RE: Public Comment for intent to adopt mitigated negative declaration –
MST1999-00714, MST99-00513, MST98-00706, MST2003-00652 &
MST1999-01043 and public environmental hearing

RE: Draft Mitigated Negative Declaration-MST1999-00714; MST99-00513; MST98-00706; MST2003-00652; & MST1999-01043---1568,1570,1575, & 1576 La Vista del Oceano Project

The Project: 1568-1576 La Vista Del Oceano Drive, Santa Barbara, CA

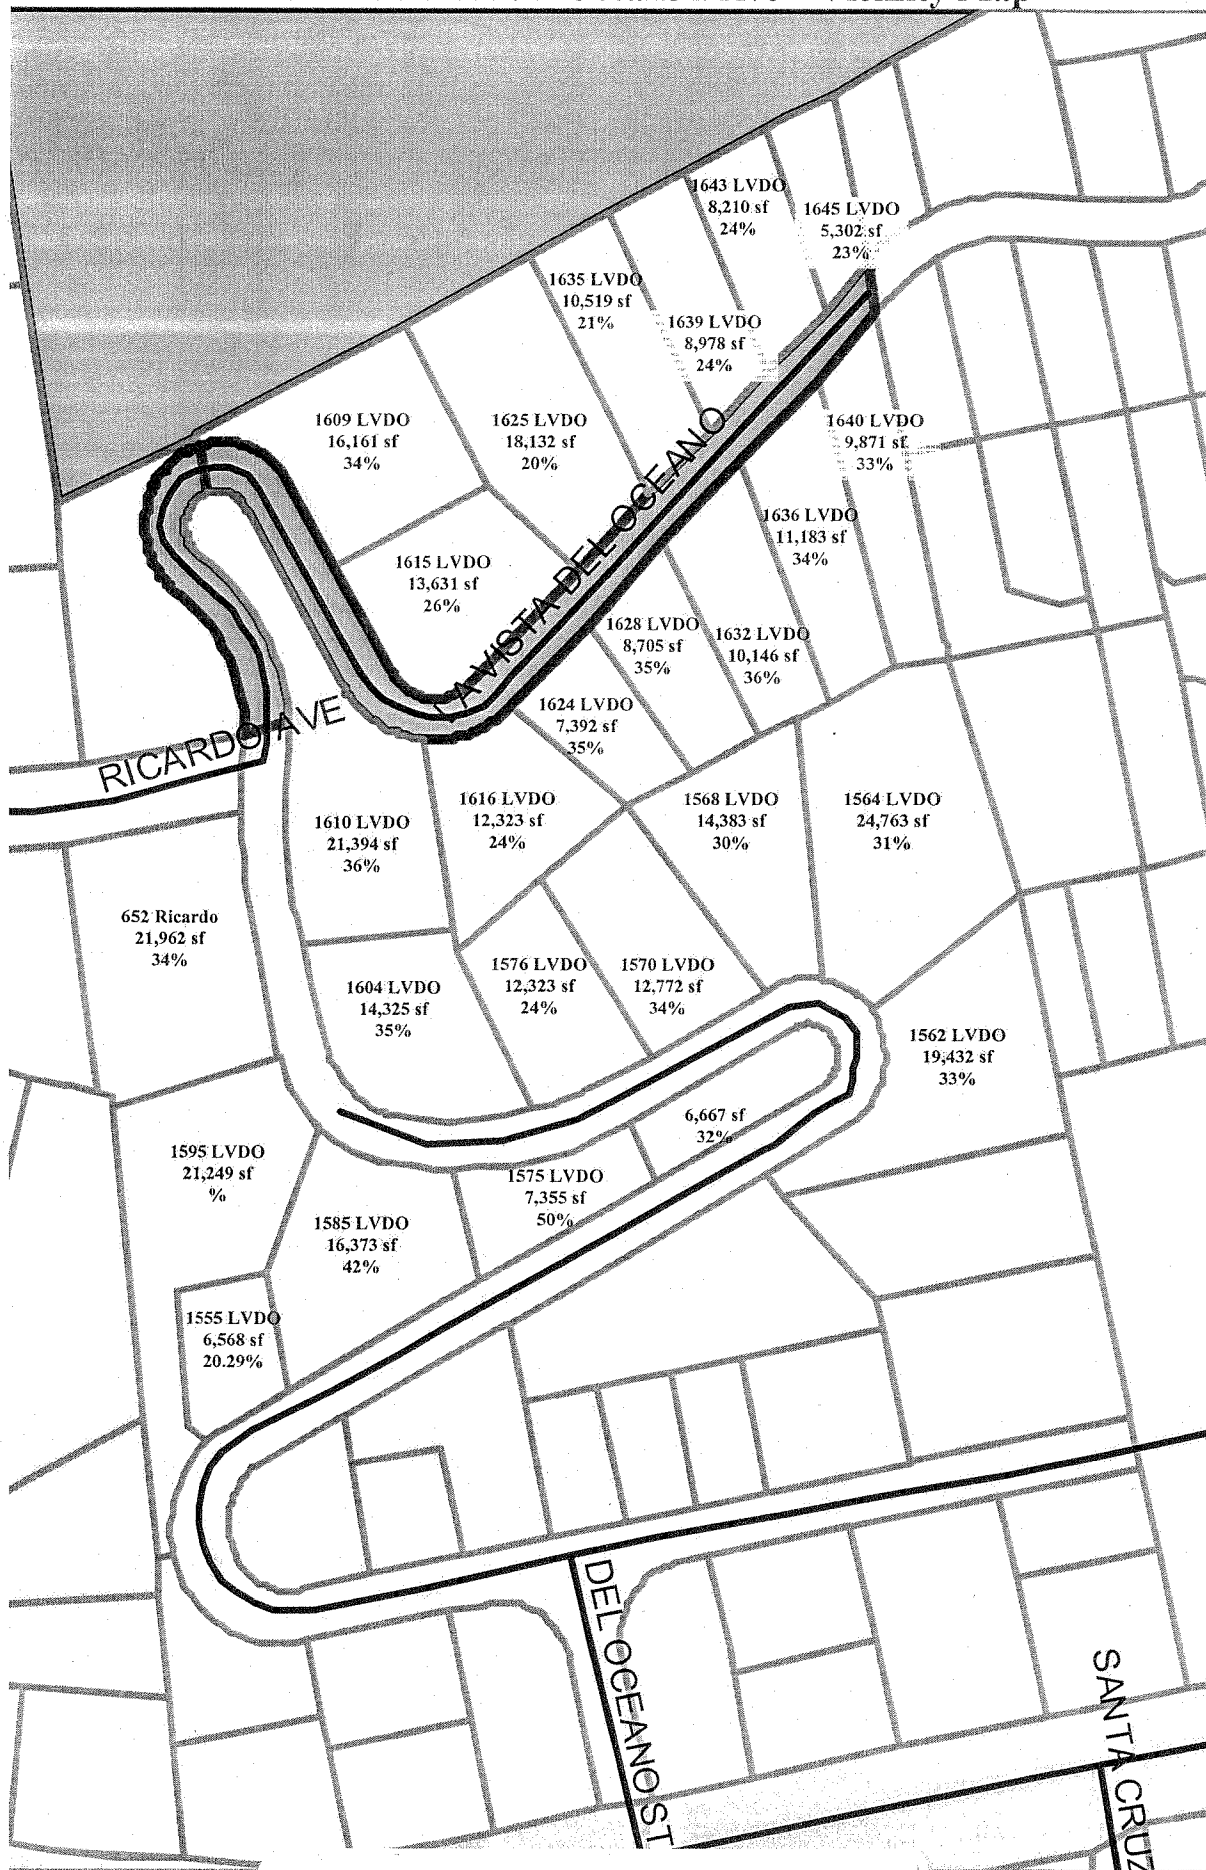
Will the ABR be looking at the story poles while they are still in place? In particular, I would like to have them check the Geyer residence.

The floor elevations have been reduced slightly, and the South Elevation has been changed in an attempt to reduce the appearance of height, but the structure is very close the original in mass, bulk and scale. Some or all of the plate heights are ten feet where they could be eight feet. From our vantage point, the rear part of the structure is very tall and narrow.

I see three possible solutions:

- 1.) Remove the third floor, and put it to the rear of the second floor. An example of that solution is our residence immediately to the west at 1604 LVDO.
- 2.) Move the entire structure, or the upper floors, to the north such that the third floor is on grade at the rear.
- 3.) Lower the entire structure such that the third floor is on grade at the rear.
